UNITED STATES
DEPARTMENT OF THE INTERIOR
BUREAU OF LAND MANAGEMENTFORM APPROVED
OMB NO. 1004-0137
Expires: January 31, 2018**SUNDRY NOTICES AND REPORTS ON WELLS**
*Do not use this form for proposals to drill or to re-enter an abandoned well. Use form 3160-3 (APD) for such proposals.*5. Lease Serial No.
NMLC062300

CO YETI 15 22 FED COM 0053H

This sundry is to clarify the original COA's regarding pressure control equipment. The 5M BOP will be utilized on these wells after the surface shoe and throughout the entirety of the wellbore thereafter. The TVD for these wells are no deeper than 10,700' with pore pressures of 9.5 ppg. Therefore the MASP will NOT exceed 5M psi.

**PECOS DISTRICT
DRILLING CONDITIONS OF APPROVAL**

BLOWOUT PREVENTER SCHEMATIC

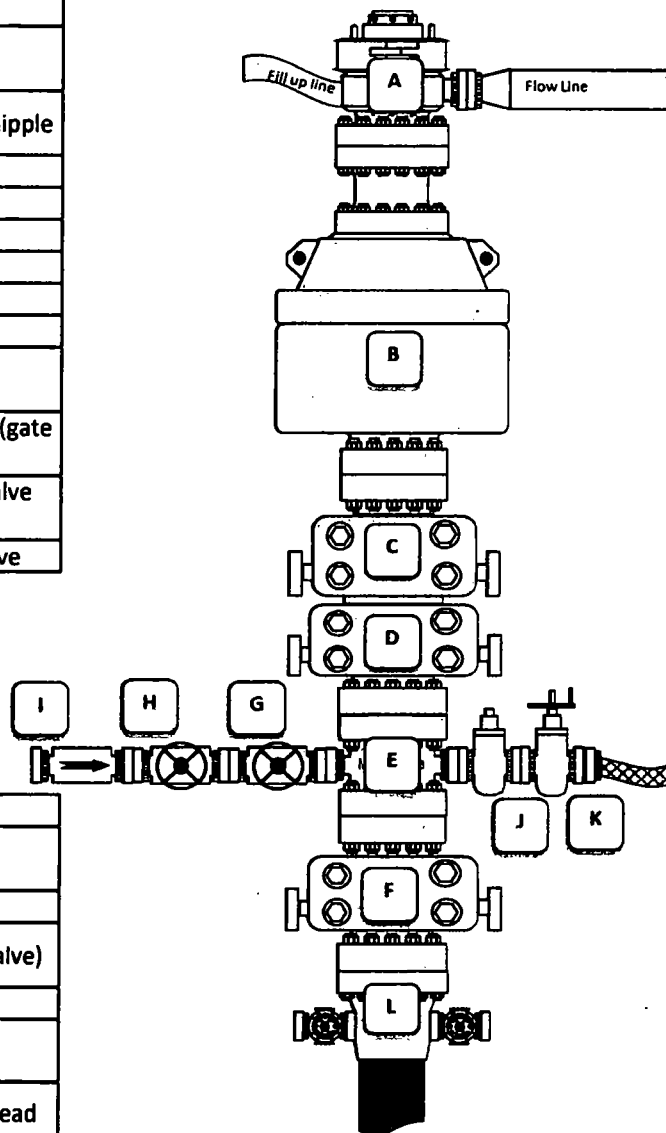
See attached BOP and choke manifold

1. Variance approved to use flex line from BOP to choke manifold. Manufacturer's specification to be readily available. No external damage to flex line. Flex line to be installed as straight as possible (no hard bends).'
- 2.

- a. Minimum working pressure of the blowout preventer (BOP) and related equipment (BOPE) required for drilling below the surface casing shoe shall be **5000 (5M)** psi.
- b. Minimum working pressure of the blowout preventer (BOP) and related equipment (BOPE) required for drilling below the intermediate casing shoe shall be **10,000 (10M)** psi.
